NP-12-0028
July 13, 2012

Subject: Exelon Nuclear Texas Holdings, LLC
Victoria County Station
Early Site Permit Application
Environmental Report – Responses to ER RAI Letters No.12 and No.13
Docket No. 52-042

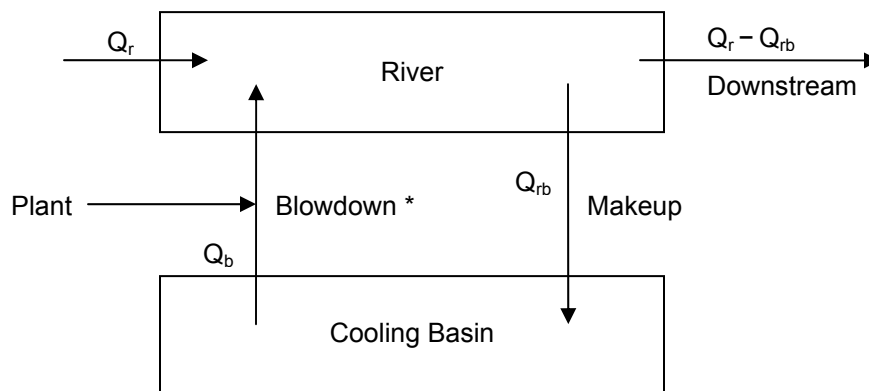
RW 3.5.-2 - ESRP Section 3.5 directs the staff to review the applicant's design of radioactive waste management and effluent control systems presented in the Environmental Report (ER). The blowdown discharge location for liquid effluent release is upstream of the raw water makeup intake structure (ER Figure 2.3.1-1). The releases upstream have a potential to get in the cooling basin through the raw water makeup system downstream. This mechanism could result in contaminating the cooling basin. ESRP Section 5.4.2 directs the staff to review the applicant's evaluation of doses due to radioactive gaseous and liquid effluent discharges presented in the ER. Licensees are responsible for evaluating any new exposure pathways and the resultant radiological hazards associated with the return of radioactive material to the operating facility and its subsequent discharge to the environment. As described in Regulatory Guide 1.109, "Calculation of Annual Doses to Man from Routine Releases of Reactor Effluents for the Purpose of Evaluating Compliance with 10 CFR Part 50, Appendix I, "Revision 1, issued October 1977, licensees must evaluate any new exposure pathways to members of the public that contribute 10 percent or more of the total effluent dose and include these dose assessments in their demonstration of compliance with Appendix I to 10 CFR Part 50 Agencywide Documents Access and Management System at Accession No. ML072120368. Provide an evaluation of the potential radioactivity buildup concentration (pCi/L) in the cooling basin from the operation of proposed VCS units. Additionally, based on the radioactivity buildup concentration in the cooling basin, provide estimate of dose impacts to different receptors.

Liquid effluent from the proposed facility is to be discharged into the Guadalupe River via the cooling basin blowdown line. Downstream of the discharge point, a fraction of the river water is diverted to the plant as makeup for the cooling basin. As indicated in Regulatory Guide 1.113, for large water volumes with small blowdown rates, the concentrations of long-lived isotopes may build up over a period of several years [Ref 1, Sheet 37].
